Appl. No.: 10/709,679  
Amdt. Dated: 7/6/2005  
Reply to Office action of: 05/09/2005

**AMENDMENTSTOTHEDRAWINGS:**

The attached sheet(s) of drawings includes amended Figures 3 and 4 having two omitted numbers added to identify clearly two of the elements shown therein, and new Figures 5 and 6.

Fig. 3

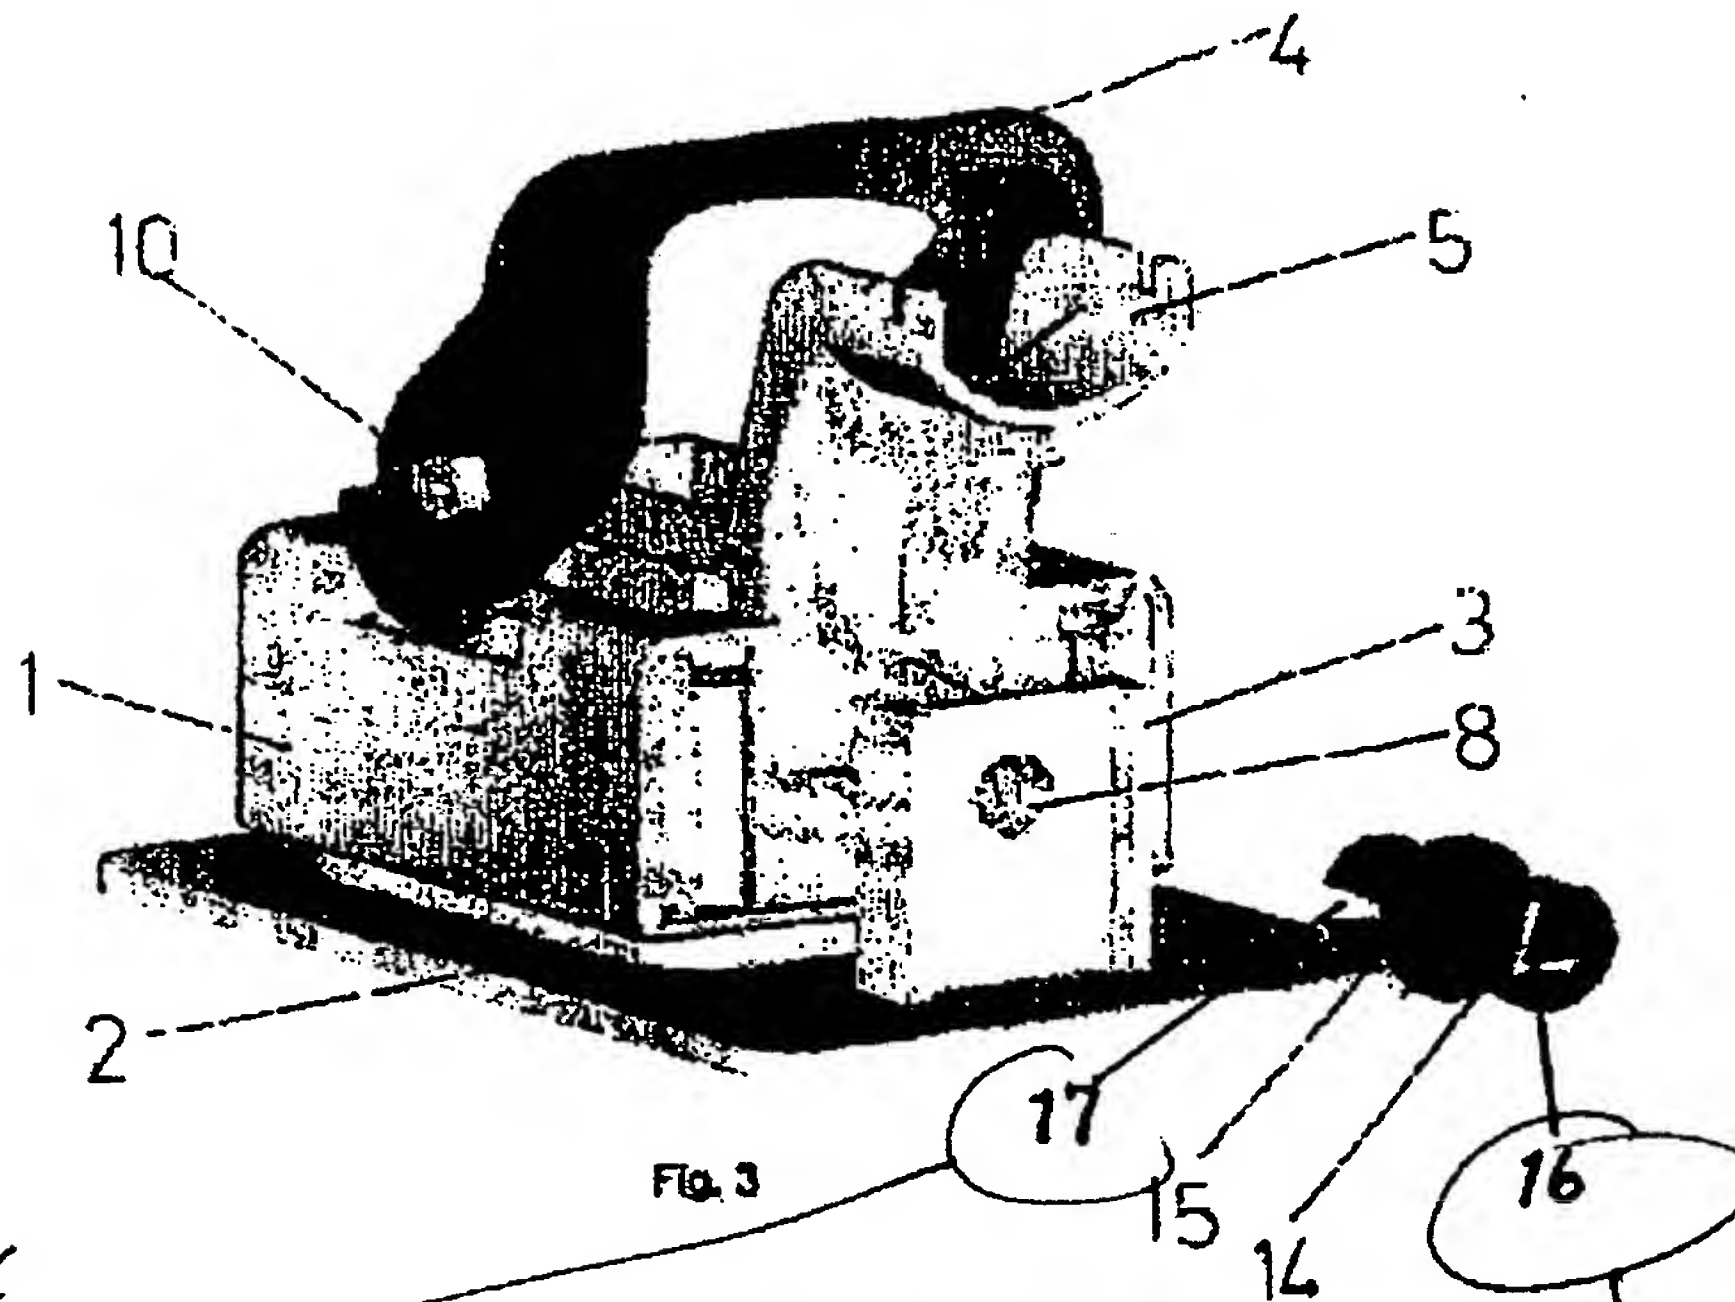
Amended Figures 3 and 4 label the non-universal screw head slot and the sidewall opening in the trunco-conical part.

*Element  
 17 Added*

Fig. 4

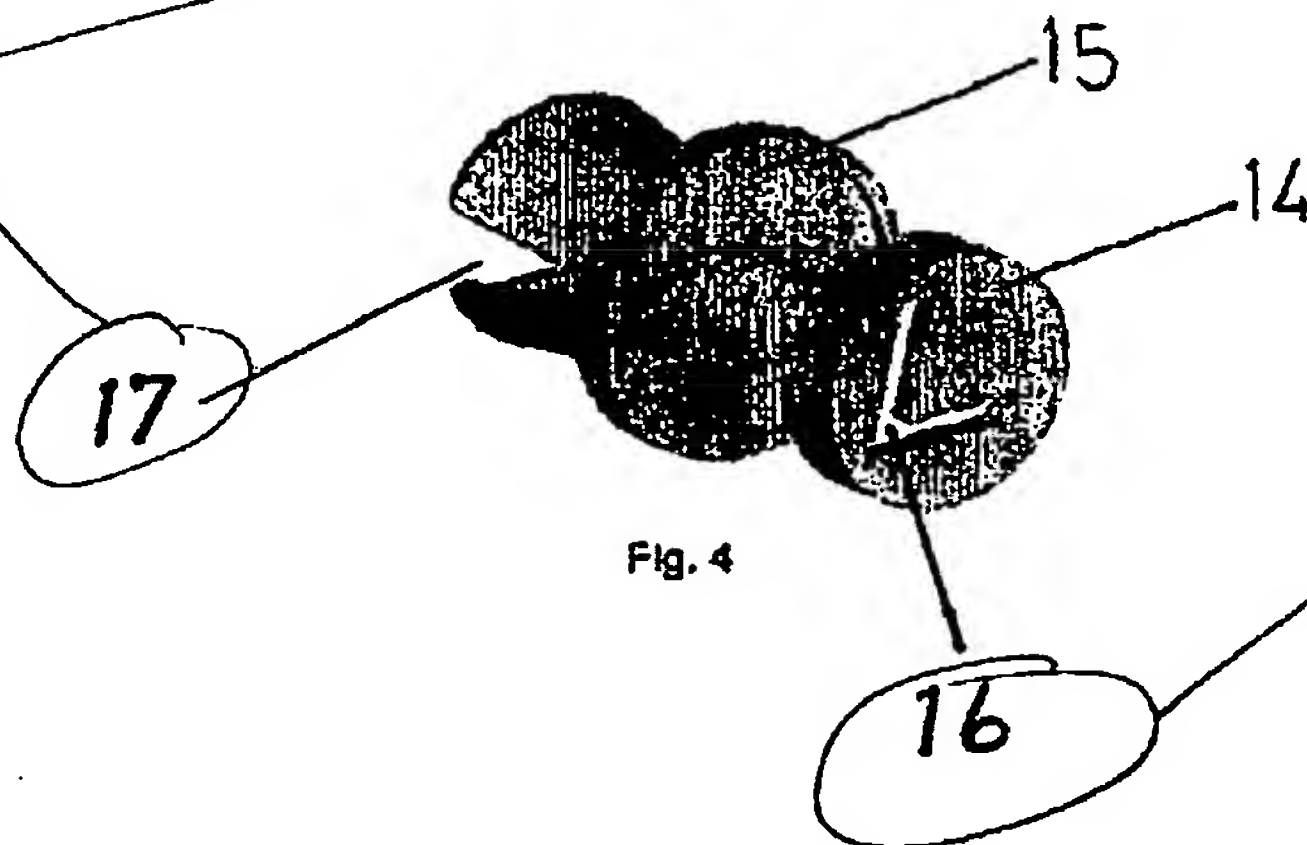
*Element 16  
 added*
